ZA 8-21-2019  
Item # 5.a.  
Planning Department <planning@edcgov.us>  
(10 pages)

## Fwd: Variance: V18-0005/Chellappan & Notice of Public Hearing on August 21, 2019 (at 3:00PM)

## Response to V18-0005/Chellappan Variance

File Number: V18-0005/Chellappan Variance

**V18-0005 EXHIBIT J - DRIVEWAY LINE OF SIGHT ANALYSIS**

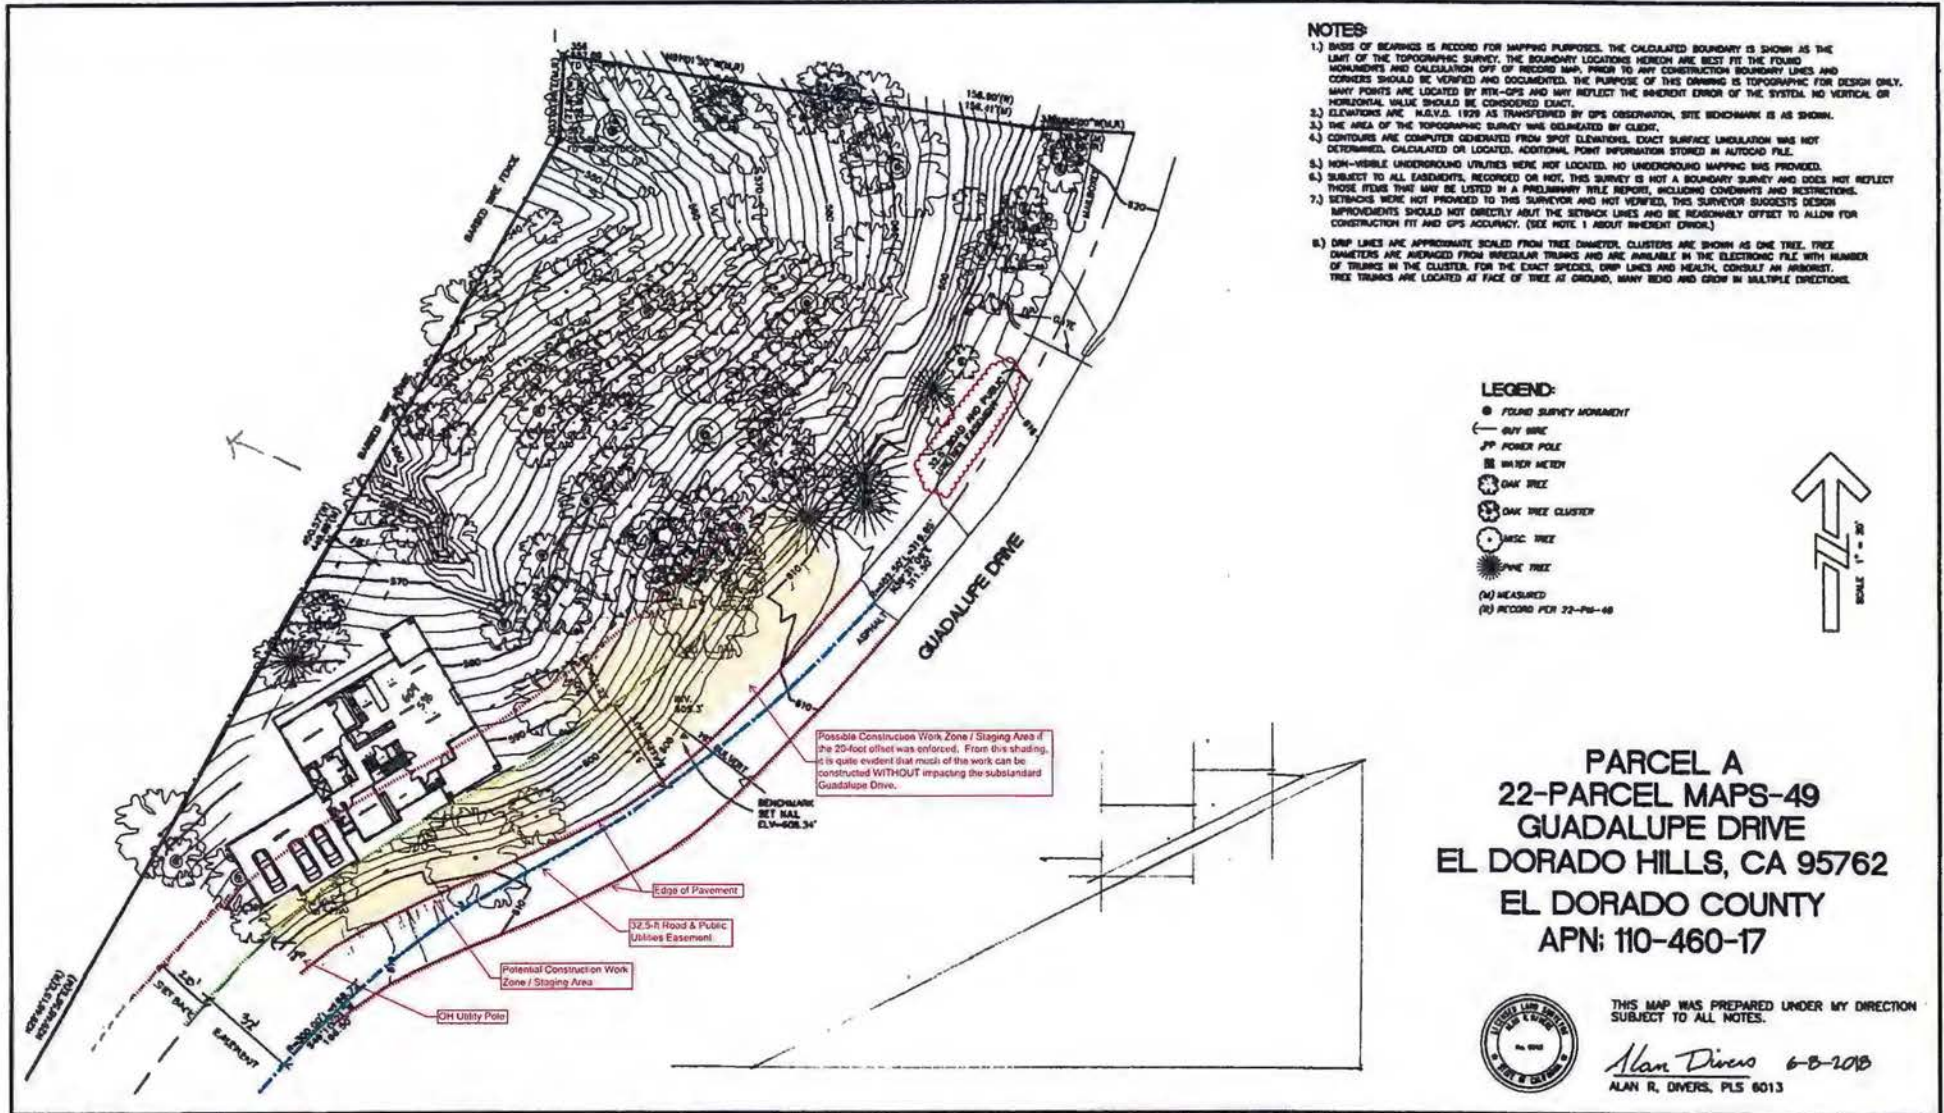
Also, I have attached "marked up" portions of Exhibit J (Driveway Line of Sight Analysis) and Exhibit O (Project Site Plan) with additional comments regarding the impacts of the zero-foot offset. These marked up drawings are for your information and for the record. In addition, I have attached a Road Evaluation created by ACE Quality Control documenting the condition of Guadalupe Drive within the Lake Pointe View neighborhood. This Road Evaluation details the substandard condition of this portion of Guadalupe Drive.

In Exhibit J, the analysis notes that the proposed driveway would have an adequate sight distance based on "DOT figure 201.2", and that the driveway would have "safe stopping sight distances of 100 feet for a left turn and 225 feet for a right turn". Again, this analysis does not appear to take into consideration the steepness of the proposed driveway, or if the vehicle were backing out of the driveway and onto Guadalupe Drive.

Figure 1 - Portion of Exhibit O - Color Coded to show limited Construction Work Zone

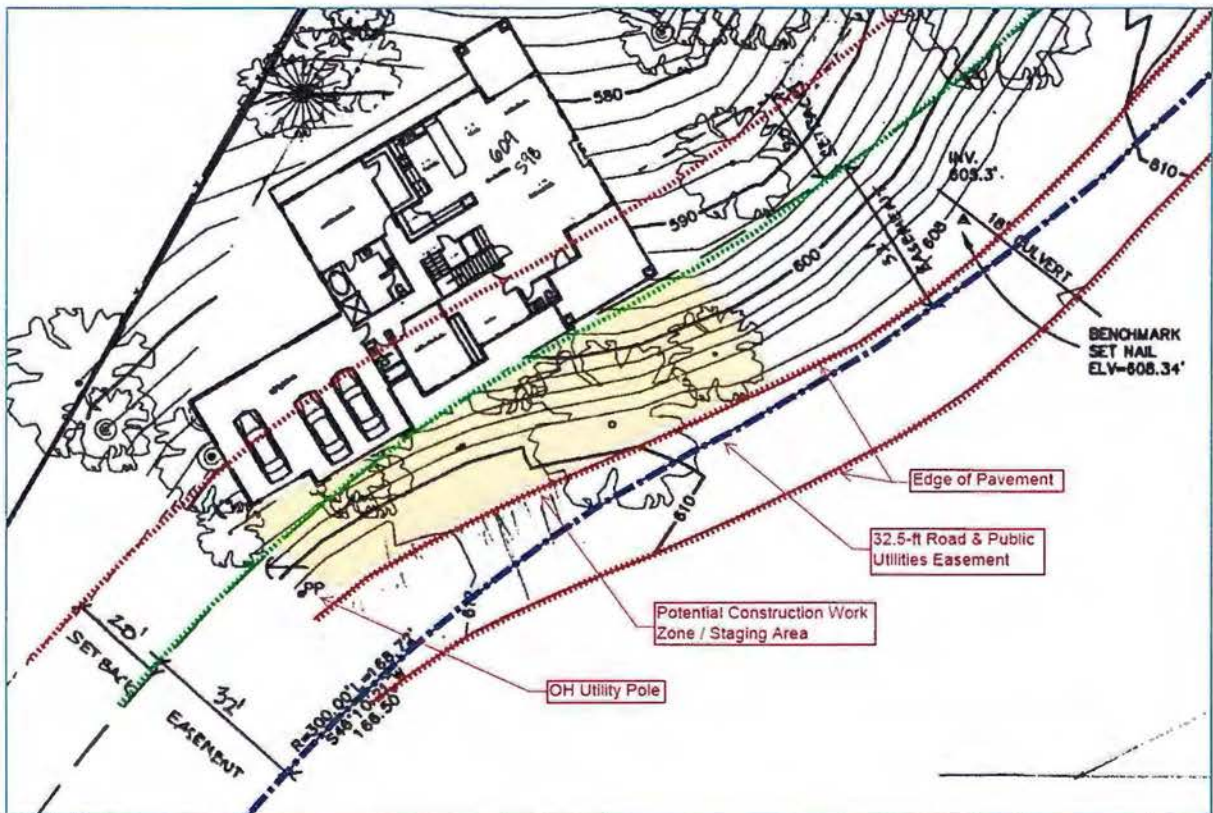
In the figure below, the it is quite clear to see that the northern edge of pavement is extremely close to the edge of the 32.5-ft easement. The limited Construction Wok Zone / Staging Area has a high potential to damage Guadalupe Drive within these limits. In addition, this limited work zone has a high potential to block the roadway and cause potential safety issues due to the blind corner west of the work zone.

In conclusion, it is the position of the Lake Pointe View neighborhood that this variance should not be granted because of the high potential for damage to the existing roadway. Also, if the variance is

granted, it is the position of the LPV neighborhood that Mr. Chellappan should be responsible for repairs of the entire roadway width within his right of way limits. Also, Mr. Chellappan should be responsible for traffic control measures to ensure the safety of all residents.

Figure 3 - Automobile is approximately four feet into Guadalupe Drive for this analysis.

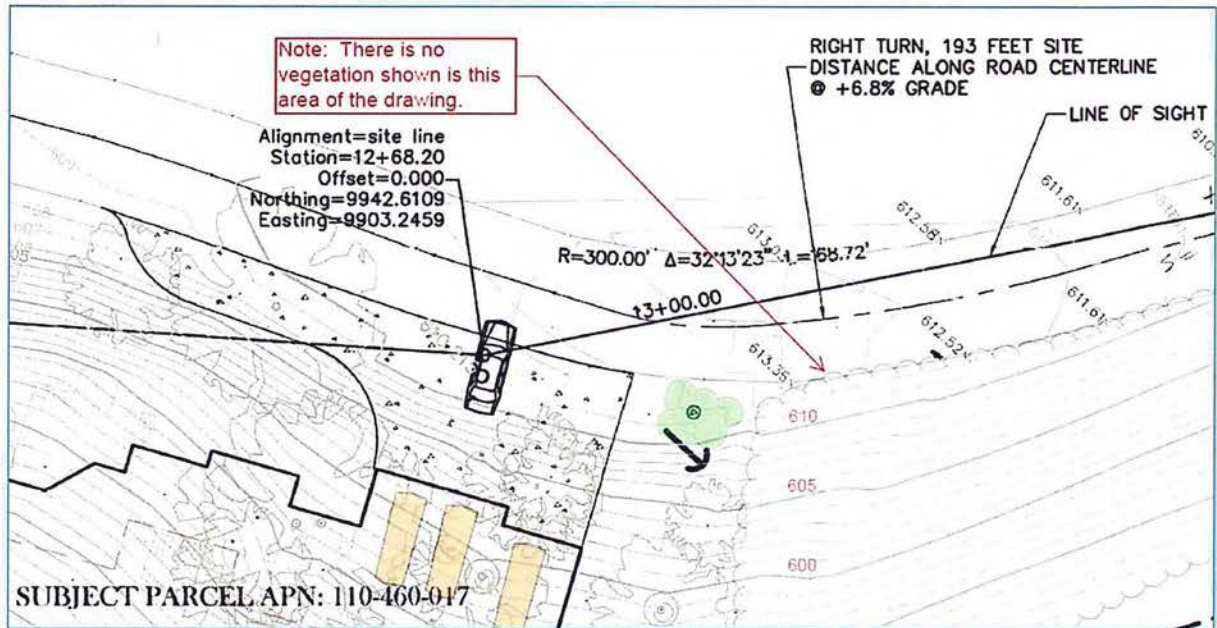
In Figure 3 (below) a portion of Exhibit J is shown. From this figure, it is clear that the vehicle is approximately four feet into the roadway when determining a "Line of Sight". Also, if the front of the vehicle were "pushed back" to the edge of pavement, it's clear that due to the steepness of the existing ground, the proposed driveway may not be a level for the entire length of the vehicle and that the driver's vision may be obstructed by vegetation and the overhead power pole (color coded in green) adjacent to the roadway.

Furthermore, from the analysis in Exhibit J, there was no mention of what the "line of sight" would be if the vehicle were to back out of the driveway and onto Guadalupe Drive. It does not seem prudent (or safe) to assume that vehicle will always drive forward out of the driveway and onto Guadalupe Drive. It seems as if a conservative approach would be to perform the analysis with a vehicle backing out of a steep driveway from the garage bay furthest from the uphill approach (west of proposed site).

Note: As there are no building plans yet available for this project, there is no way to know exactly how steep the future driveway will be and its exact location relative Guadalupe Drive. In Figure 3, the vehicle is at an approximate elevation of 612 feet, while the existing ground elevation of the western corner of the garage is approximately 603 feet. So, there is a difference of nine feet between the existing ground and the location of the vehicle in this analysis.

Figure 4 - What If Examples of Vehicle Location and Right Turn Sight Distances

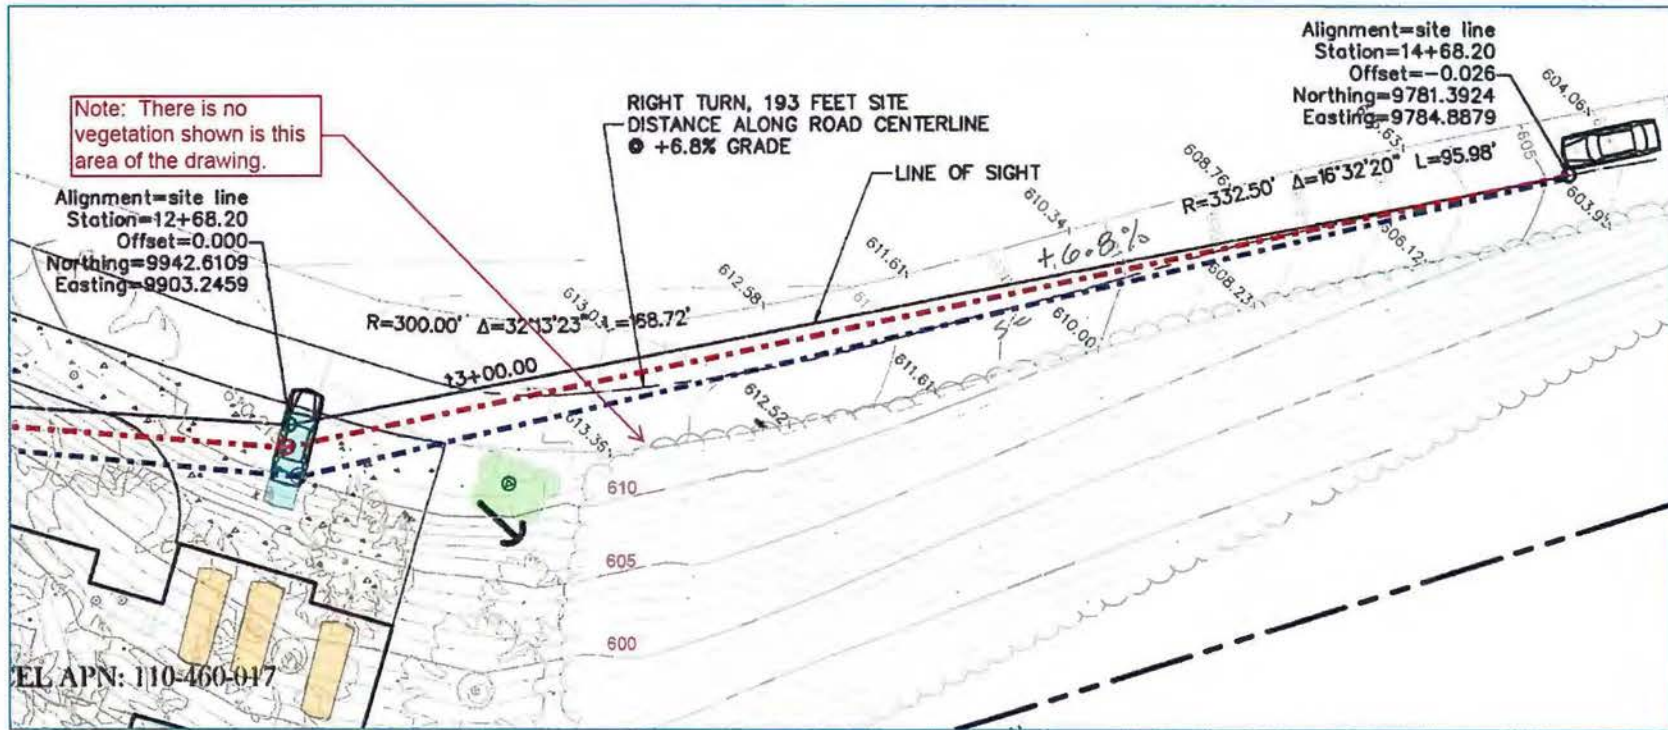
In Figure 4, the location of the vehicle (as shown in light blue) was adjusted so that it was not four feet into Guadalupe Drive. The red line represents what the "Line of Sight" would be if the vehicle was driving forward out of the proposed driveway. From this scenario, it is apparent that the line of sight could be obstructed by the slope of a steep driveway. In the second scenario, the blue line represents a vehicle backing out of the driveway onto Guadalupe Drive. Again, from this scenario, it is apparent that the line of sight could be severely obstructed by the slope of a steep driveway and possible the horizontal and vertical curves of the roadway. Note: The Left Turn alignments of the red and blue lines seem to be partially obstructed by existing trees. This portion of the drawing was not shown for brevity purposes.

Based on these concerns, the Lake Pointe View neighborhood would like further analysis of a safe Stopping Sight Distance based on a vehicle driving forwards and backwards from the driveway onto Guadalupe Drive and for this analysis to consider the steepness of the proposed driveway.

Figure 1 - Portion of Exhibit O - Color Coded to show limited Construction Work Zone

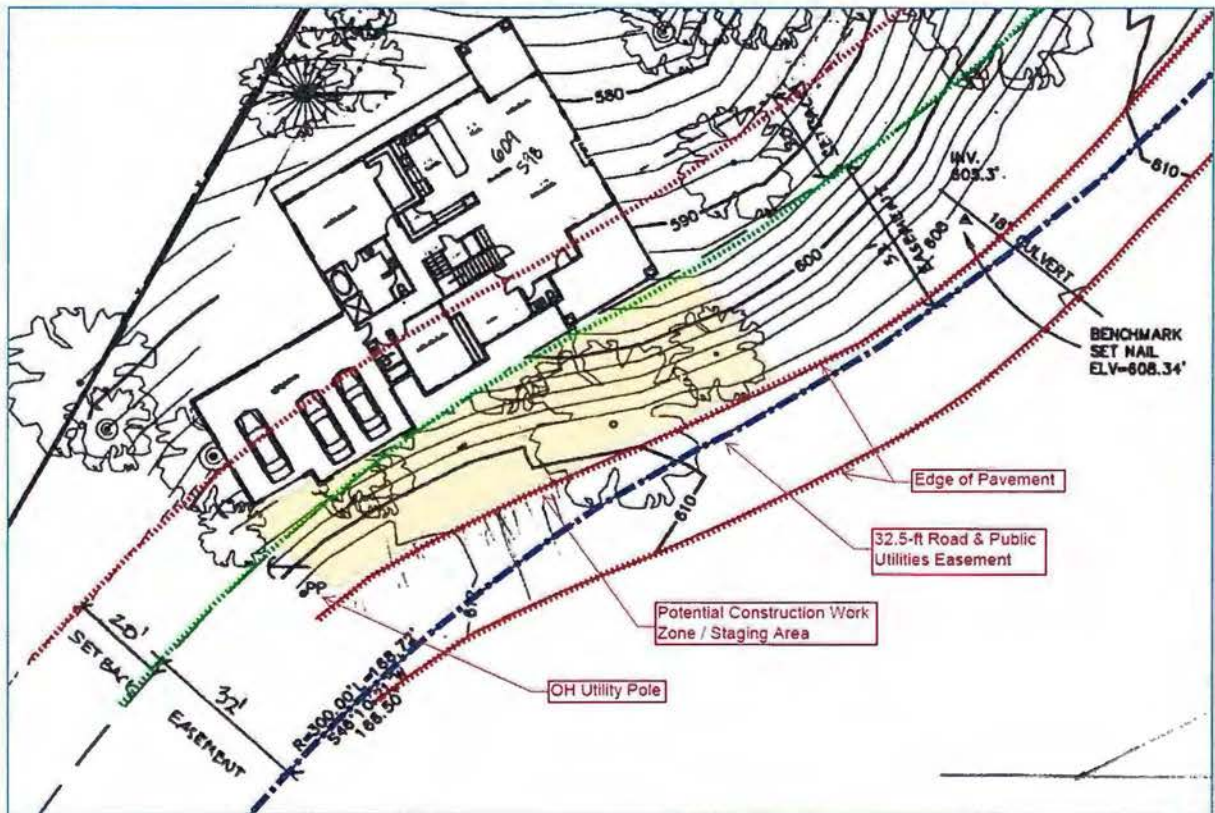
In the figure below, the it is quite clear to see that the northern edge of pavement is extremely close to the edge of the 32.5-ft easement. The limited Construction Wok Zone / Staging Area has a high potential to damage Guadalupe Drive within these limits. In addition, this limited work zone has a high potential to block the roadway and cause potential safety issues due to the blind corner west of the work zone.

In conclusion, it is the position of the Lake Pointe View neighborhood that this variance should not be granted because of the high potential for damage to the existing roadway. Also, if the variance is

granted, it is the position of the LPV neighborhood that Mr. Chellappan should be responsible for repairs of the entire roadway width within his right of way limits. Also, Mr. Chellappan should be responsible for traffic control measures to ensure the safety of all residents.

Figure 3 - Automobile is approximately four feet into Guadalupe Drive for this analysis.

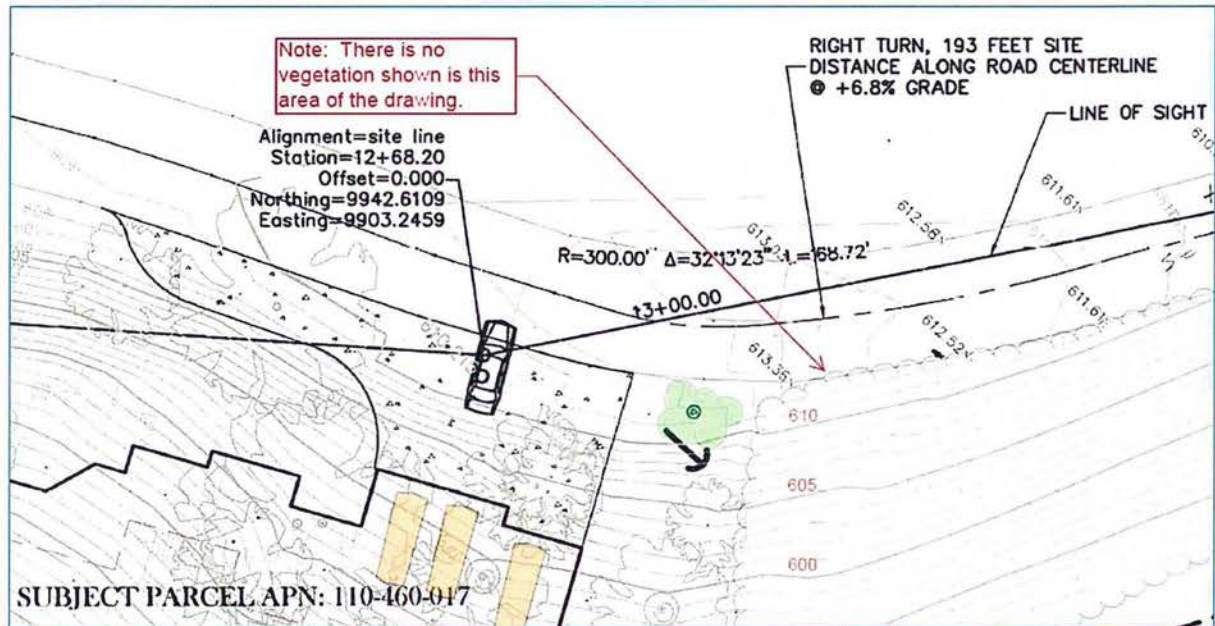
In Figure 3 (below) a portion of Exhibit J is shown. From this figure, it is clear that the vehicle is approximately four feet into the roadway when determining a "Line of Sight". Also, if the front of the vehicle were "pushed back" to the edge of pavement, it's clear that due to the steepness of the existing ground, the proposed driveway may not be a level for the entire length of the vehicle and that the driver's vision may be obstructed by vegetation and the overhead power pole (color coded in green) adjacent to the roadway.

Furthermore, from the analysis in Exhibit J, there was no mention of what the "line of sight" would be if the vehicle were to back out of the driveway and onto Guadalupe Drive. It does not seem prudent (or safe) to assume that vehicle will always drive forward out of the driveway and onto Guadalupe Drive. It seems as if a conservative approach would be to perform the analysis with a vehicle backing out of a steep driveway from the garage bay furthest from the uphill approach (west of proposed site).

Note: As there are no building plans yet available for this project, there is no way to know exactly how steep the future driveway will be and its exact location relative Guadalupe Drive. In Figure 3, the vehicle is at an approximate elevation of 612 feet, while the existing ground elevation of the western corner of the garage is approximately 603 feet. So, there is a difference of nine feet between the existing ground and the location of the vehicle in this analysis.

Figure 4 - What If Examples of Vehicle Location and Right Turn Sight Distances

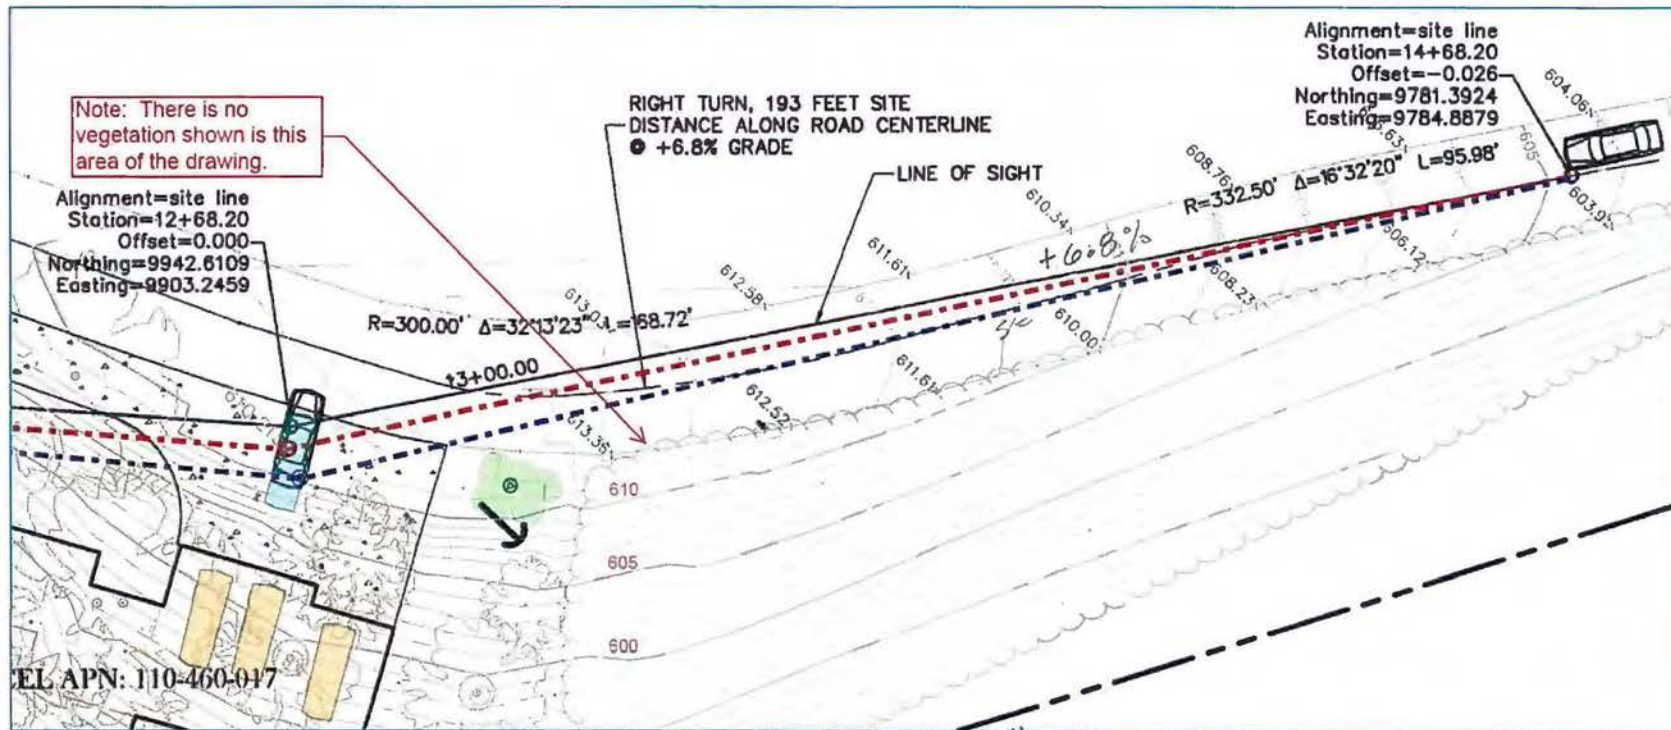
In Figure 4, the location of the vehicle (as shown in light blue) was adjusted so that it was not four feet into Guadalupe Drive. The red line represents what the "Line of Sight" would be if the vehicle was driving forward out of the proposed driveway. From this scenario, it is apparent that the line of sight could be obstructed by the slope of a steep driveway. In the second scenario, the blue line represents a vehicle backing out of the driveway onto Guadalupe Drive. Again, from this scenario, it is apparent that the line of sight could be severely obstructed by the slope of a steep driveway and possible the horizontal and vertical curves of the roadway. Note: The Left Turn alignments of the red and blue lines seem to be partially obstructed by existing trees. This portion of the drawing was not shown for brevity purposes.

Based on these concerns, the Lake Pointe View neighborhood would like further analysis of a safe Stopping Sight Distance based on a vehicle driving forwards and backwards from the driveway onto Guadalupe Drive and for this analysis to consider the steepness of the proposed driveway.
